SERVICE BULLETIN

SERVICE BULLETIN NO: 31-003

INDICATING/RECORDING SYSTEMS INSTRUMENT AND CONTROL PANELS - REPLACEMENT OF THE SWITCH CAPS ON THE OVERHEAD PANEL

Overhead Panel - Switch Cap Configuration
Figure 1 (Sheet 2 of 2)

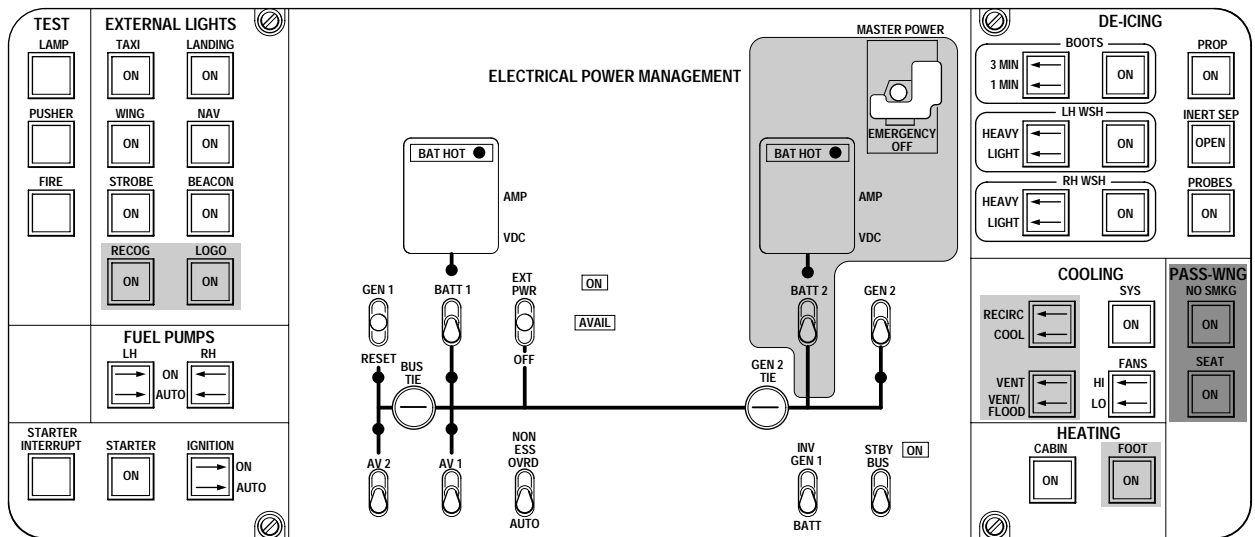
B. Modification of the Overhead Panel (Ref. Fig. 1)

Figure 1 shows all configurations of the overhead panel. Install only the applicable switch caps for the given aircraft configuration.

Replace only the switch caps with ON, OPEN or no caption/symbol. Do not replace the switch caps that have the arrow symbol.

- (7) Make sure the switch caps stay in the front panel when you remove the PCB/backplate. This will help you to install the correct replacement switch-caps.
- (8) Remove the PCB/backplate (5).
- (9) Replace the switch caps (6) one at a time. When you do this, make sure that each new switch cap (6) and its orientation is correct. Install the switch cap with the green ON caption in the STARTER switch position.
- (10) Put the PCB/backplate (5) in position. Make sure it is flat against the front panel (2).
